**DUKE POWER**

Subject: Duke Power Company  
Catawba Nuclear Station, Unit 1  
Docket No. 50-413

Request for Additional Information (RAI)  
Request for Relief from 1989 edition of ASME Boiler  
and Pressure Vessel Code, Section XI.  
Serial No. 96-04  
TAC No. M97465

Component ID/Weld No. 1 N.I 148-10

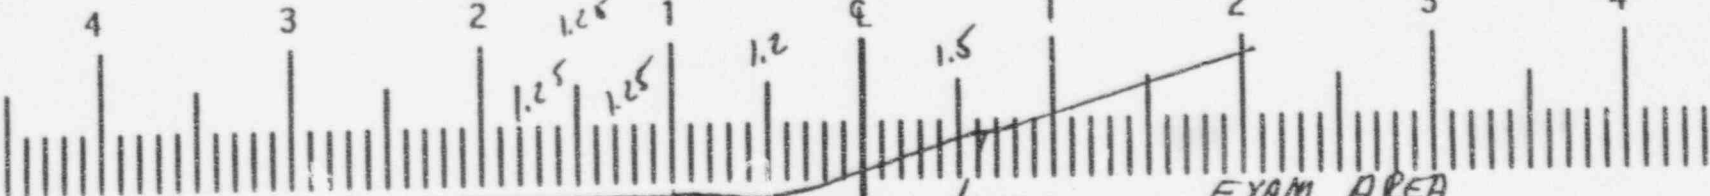
B. Section XI, Appendix III, Paragraph III-4420, Reflectors Parallel to the Weld Seam, requires examination coverage in two beam path directions to detect reflectors parallel to the weld seam. This can be accomplished by either scanning from two sides of the weld, or by using a sufficiently long beam path to provide two-directional coverage from one side of the weld. The requirement for two-directional axial scan coverage should also be reflected in the coverage calculations. However, the coverage calculations provided

with the licensee's submittal only include scan coverage in one axial direction (with two angles) and it appears that the second axial direction was not included in the calculation. As a result, the calculated coverage may be overstated. Provide a discussion regarding the examinations performed in the axial direction(s) and how the coverage was calculated.

45°/60° L AXIAL:

A-B-C  $\frac{.45 \times .25}{2} = .0562 = .06 \text{ sq. in.}$

.78 - .06 = .72 sq. in. COVERAGE

45° CIR.  
D-E-F-G

A =  $\frac{.42}{2} (.7 + .9) = .31 \text{ sq. in.}$

.34 sq. in. COVERAGE
